22 April 2026
Ref No: 3646-1012

Re: Response to Additional Information Request
Application No.: DA2025/0523
Proposal: Alterations and additions to Clarence Valley Conservatorium
Property Address: 8 Villiers Street, Grafton NSW 2460
Applicant: GeoLINK Consulting Pty Ltd

CLARENCE VALLEY CONSERVATORIUM ALTERATIONS & ADDITIONS & ADDITIONS

SITE PLAN

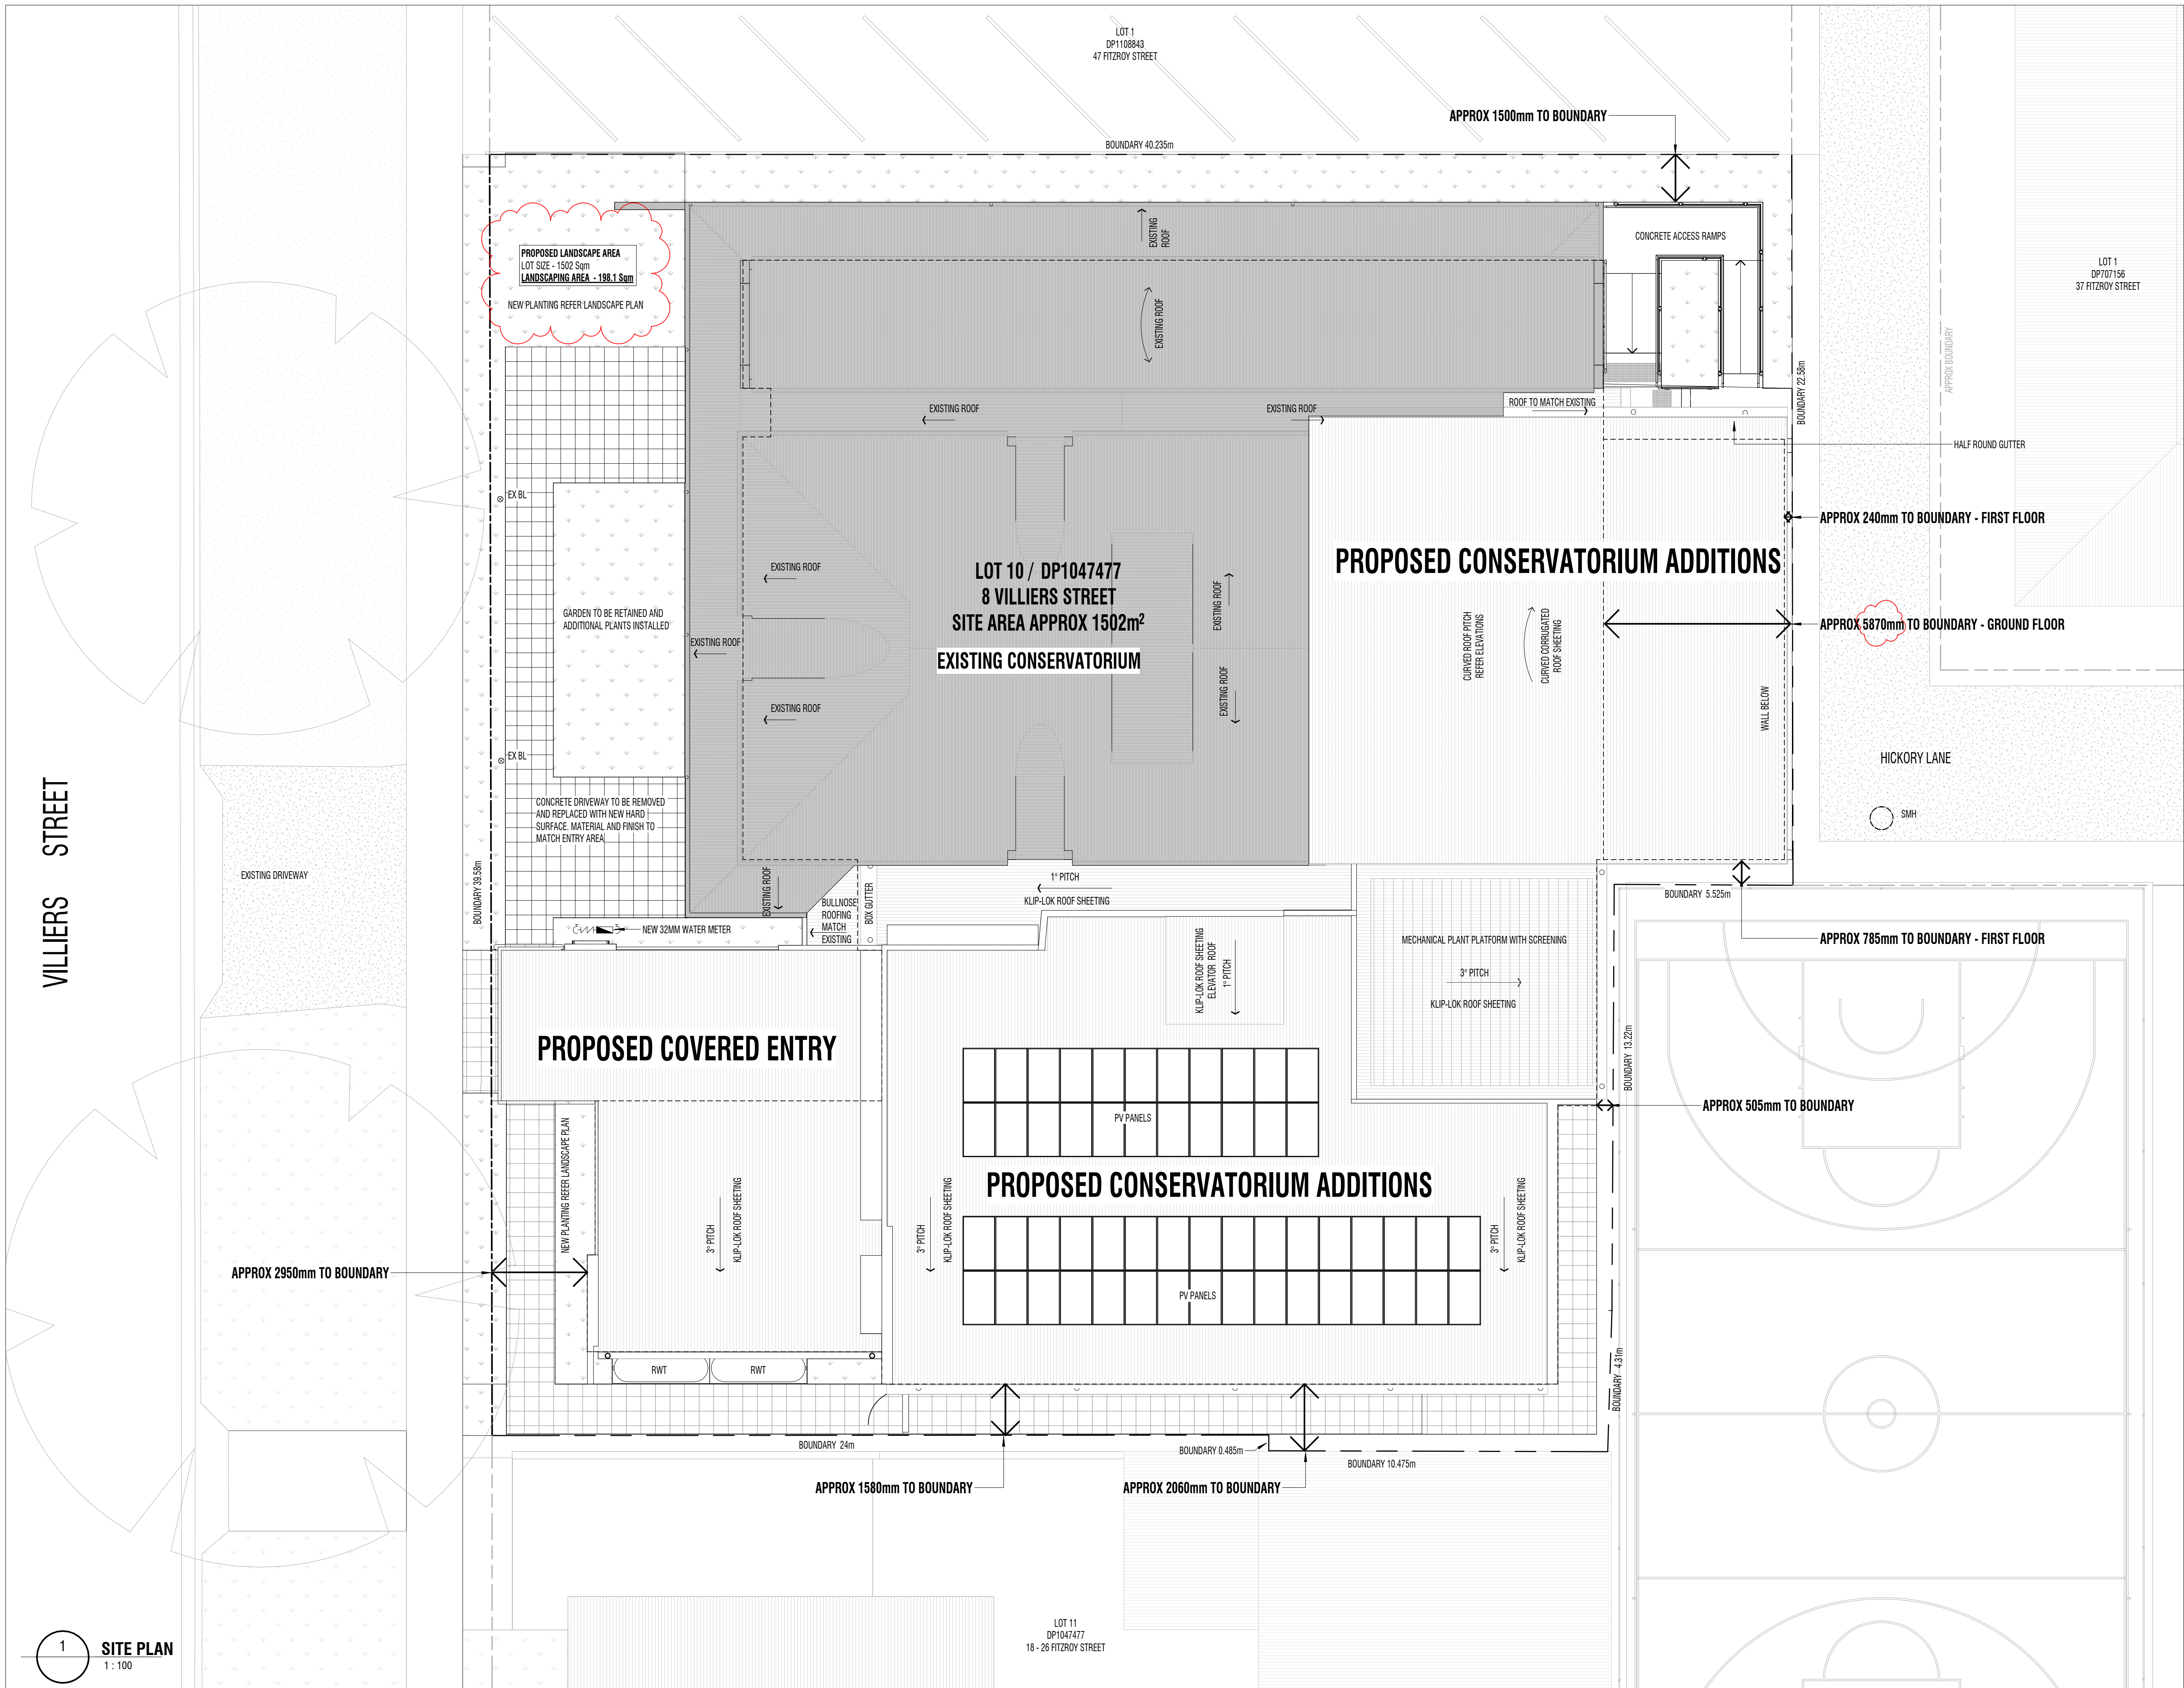
3. Residential Zones DCP Part C19 – Landscaped Area

The revised architectural plans now include a landscaped area calculation. The Site Plan (DA-2) confirms a total site area of 1,502 m² and a proposed landscaped area of 198.1 m².

Part C19 of the Residential Zones DCP requires a minimum landscaped area of 45% of the site area for development in residential zones. This requirement applies even where the land use is non-residential but assessed under the Residential DCP framework.

198.1 m² (approximately 13.2% of the site)

Landscaped areas are provided in the following locations:

- along the Villiers Street frontage, including retained garden beds and new planting;
- at the Hickory Lane interface;
- within boundary planting strips along the eastern side of the site; and
- as internal courtyard and planting pockets integrated with circulation and access paths.

PROPOSED GROUND

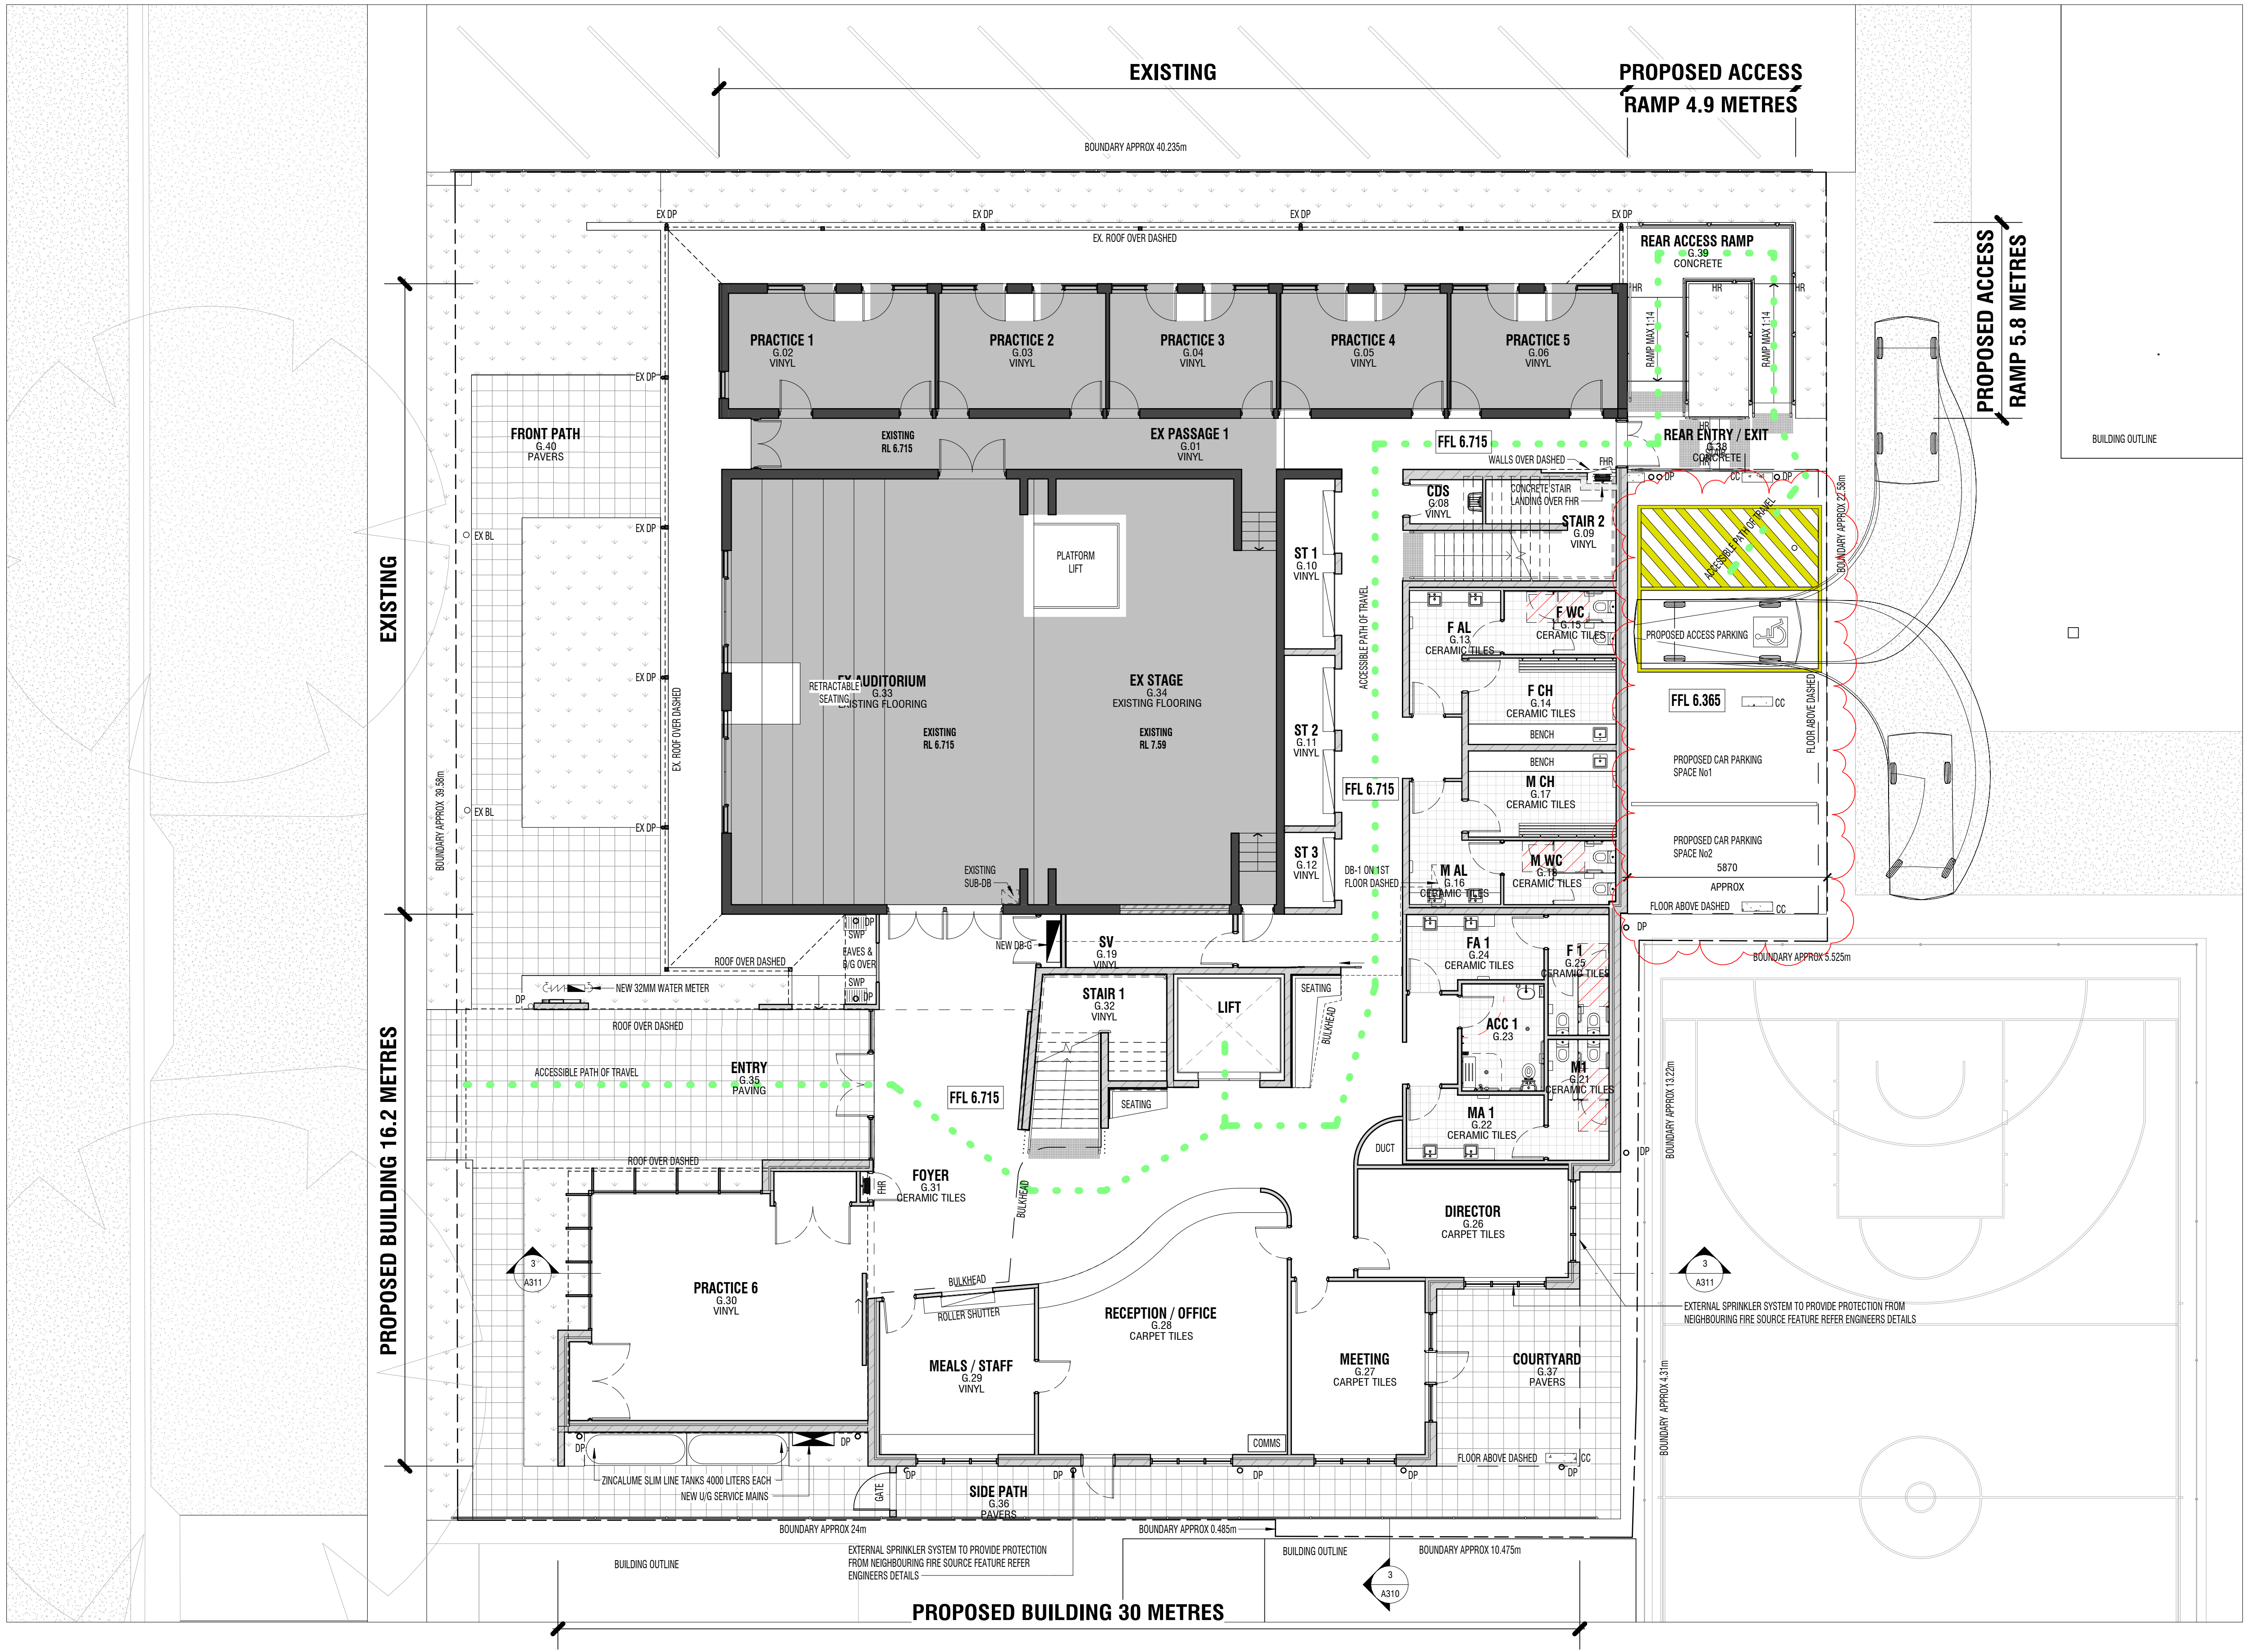
5. Car Parking Vehicle Manoeuvring

The revised plans, including the Site Plan (A050) and Proposed Ground Floor Plan (A110), demonstrate a carefully considered parking and access layout accessed via Hickory Lane. The layout prioritises:

The proposal provides two on-site car parking spaces, including one accessible parking space, located adjacent to the primary accessible entrance and lift. This configuration minimises travel distances, avoids level changes and ensures a legible and compliant accessible route from parking to the building interior.

Swept path diagrams are provided on the Proposed Ground Floor Plan (A110) demonstrating that the parking spaces can be safely accessed and exited by standard vehicles, consistent with the proposed layout.
